Access Compliance Report

Public Rights-of-Way (Curb Ramps)

Intersection ID: 52441	Main Street: WOODWARD_AV	Cross Street: BENDING_BIRCH_PL	Location: NW
ADA ID: 434272237B31	Ramp Type: Directional1	Initial Pass/Fail: Fail	Overall Compliance: No
			Severity Score: 13.75

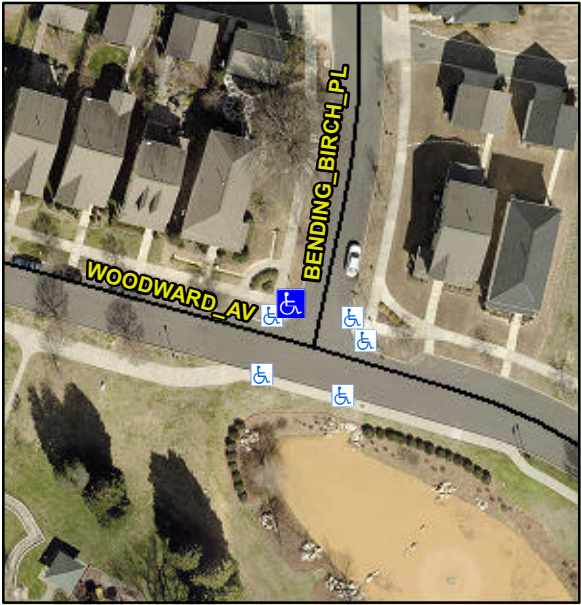
Codes/Mitigation Info/Possible Solution		Field Measurements/Component Compliance			
 <p>Street 1 Name BENDING BIRCH PL</p> <p>Stop Condition-Street 1 StopSign</p> <p>Street 2 Name N/A</p> <p>Stop Condition-Street 2 N/A</p>	Possible Solutions:	Remove & Replace Entire Ramp.			
	Surveyor Notes:	N/A			
	PROW/ADA:	R304.2.2, R304.5.3			
			Compliance	Description	Data
			N/A	Ramp Length (in)	76.0
			Yes	Ramp Width (in)	68.5
			No	Ramp Slope (%)	9.2
			No	Ramp XSlope (%)	4.3
			N/A	Flare Type LT	N/A
			N/A	Flare Slope LT (%)	N/A
			N/A	Flare Traversable LT?	N/A
			N/A	Landing Length (in)	0.0
			N/A	Landing Width (in)	0.0
			N/A	Landing Slope (%)	0.0
			N/A	Landing X Slope (%)	0.0
			N/A	Landing Curb? (Y/N)	N/A
			N/A	Shared Landing?	N/A
			N/A	Gutter Ponding?	Yes
			N/A	Gutter Lip Ht (in)	1.0
			N/A	Painted X Walk1?	No
				X Walk 1 Direction	To E
				X Walk 1 Width (in)	N/A
				X Walk 1 Slope (%)	5.9
				X Walk 1 X Slope (%)	0.5

N/A	Ramp inside XWalk1?	N/A
			N/A	Any Obstructions?	N/A
				Obstruction Type	
			Yes	Surface Condition? (G/P)	Good
			N/A	Curb Slope (%)	5.2
Total Cost:		\$ 1600.00
